Project	IEEE 802.16 Broadband Wireless Access Working Group < http://ieee802.org/16 >	
Title	P802.16h Working Document structure and purpose clarification	
Date Submitted	2006-09-25	
Source(s)	Paul Piggin NextWave Broadband Inc. 12670 High Bluff Drive San Diego CA 92130 USA	Voice: 1 858 480 3100 Fax: 1 858 480 3105 ppiggin @ nextwave.com
Re:	Working Group Review of Working Document IEEE 802.16h-06/015r1	
Abstract	This document proposes a revised structure of the P802.16h Working Document.	
Purpose		
Notice	This document has been prepared to assist IEEE 802.16. It is offered as a basis for discussion and is not binding on the contributing individual(s) or organization(s). The material in this document is subject to change in form and content after further study. The contributor(s) reserve(s) the right to add, amend or withdraw material contained herein.	
Release	The contributor grants a free, irrevocable license to the IEEE to incorporate material contained in this contribution, and any modifications thereof, in the creation of an IEEE Standards publication; to copyright in the IEEE's name any IEEE Standards publication even though it may include portions of this contribution; and a

Figure 1: Representation of the suggested Working Document structure.

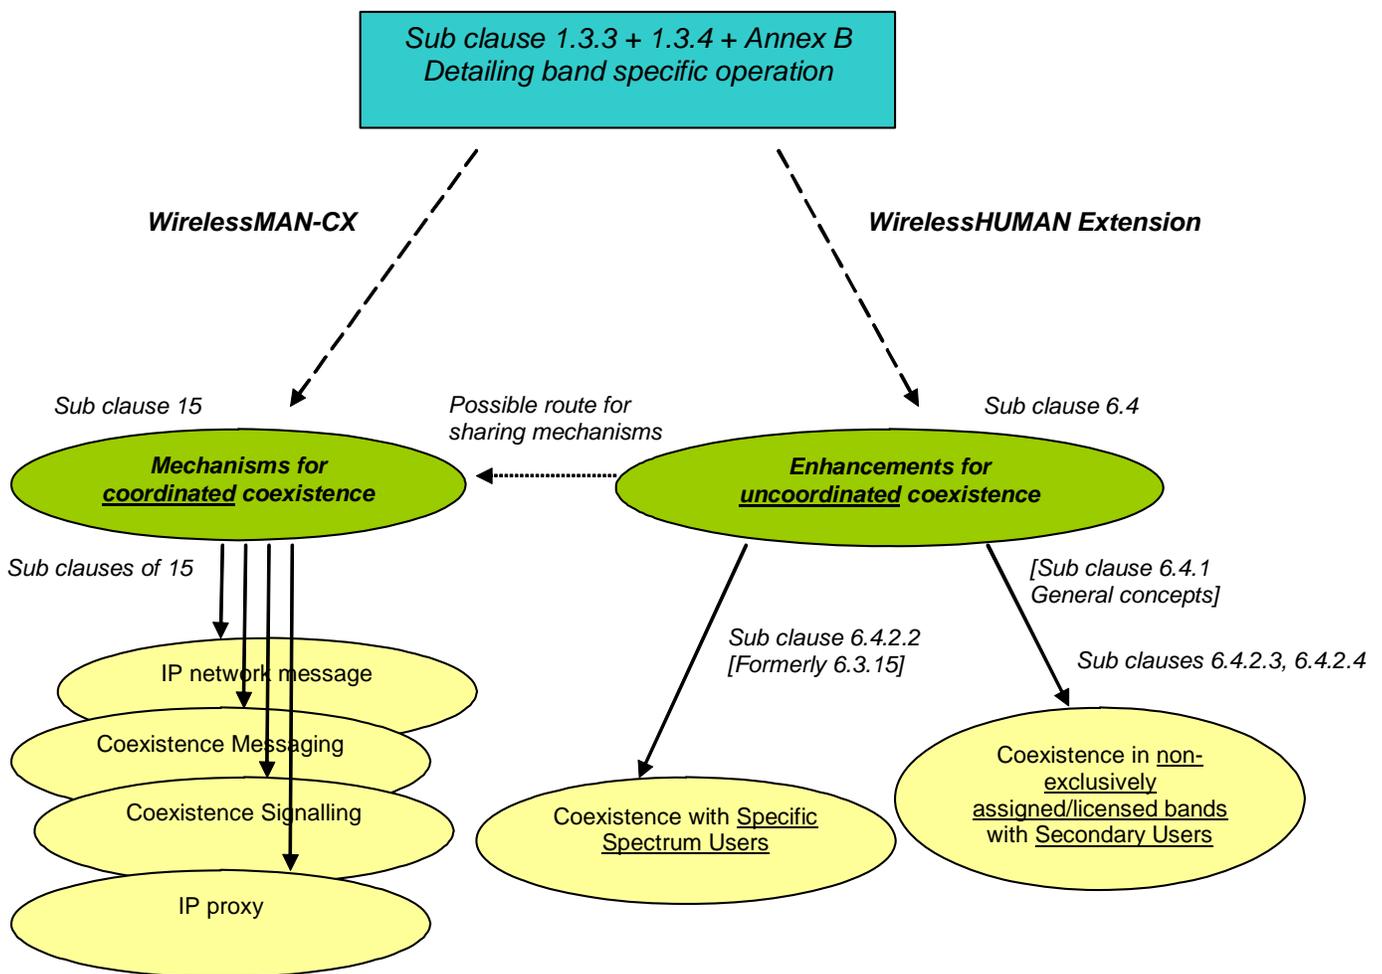
The suggested document structure is shown diagrammatically in Figure 1.

Per the definitions proposed below in this contribution, Clause 15 of [1] provides mechanisms of a coordinated nature. Subclause 6.4 of [1] addresses uncoordinated mechanisms. Contribution C802.16h-06/074 [5] proposes enhancements to those uncoordinated mechanisms. Contribution C802.16h-06/073 provides a summary of the band-specific operational requirements to be added to subclause 1.3.3 and Annex B. C802.16h-06/072 simply provides the definition of additional terms.

Figure xyz1 Link level representation of DCS operation: (a) interference and remedial action at the BS, (b) interference reporting and remedial action at the MS/SS.

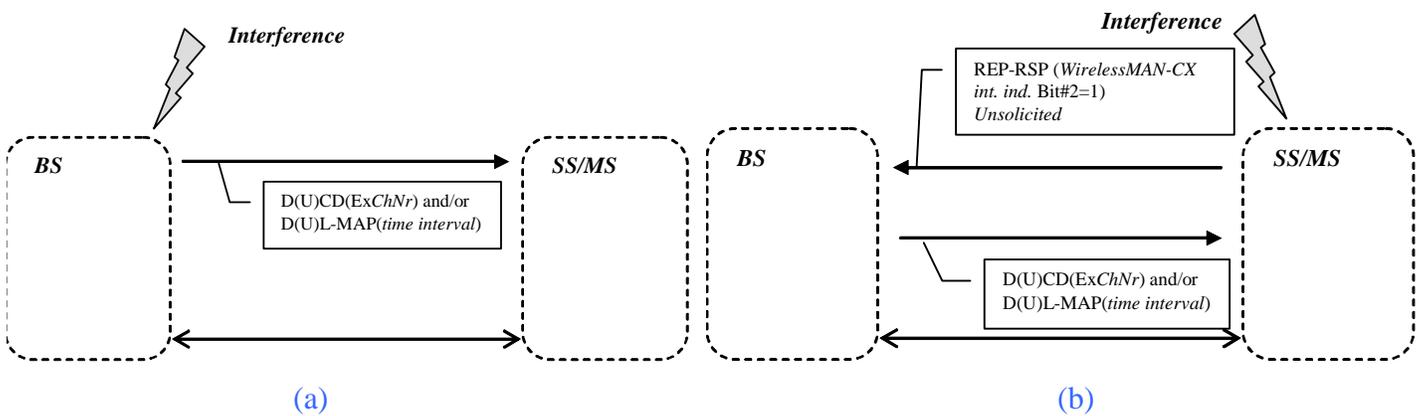
A general example of a DCS solution is provided in figure xyz1 in which interference detection provides agility in frequency and time to reduce the effects of the incident interference. Figure xyz1 (a) indicates the events that happen after interference is detected at the BS. Since the interference is deemed not to be an SSU, and therefore not protected by regulation, the DCS algorithm has the choice to either clear the channel (as would be required for the detection of an SSU) or find a less interfered area of the frame. The DCD/UCD, containing the ExChNr (6.4.1.2), is used to make the channel change, while the DL-MAP/UL-MAP provides a change of location in the frame. A similar procedure is followed for interference detection at the SS, illustrated in figure xyz1 (b), however in this case the REP-RSP, sent by the SS in an unsolicited manner, initializes the messaging undertaken by the BS.
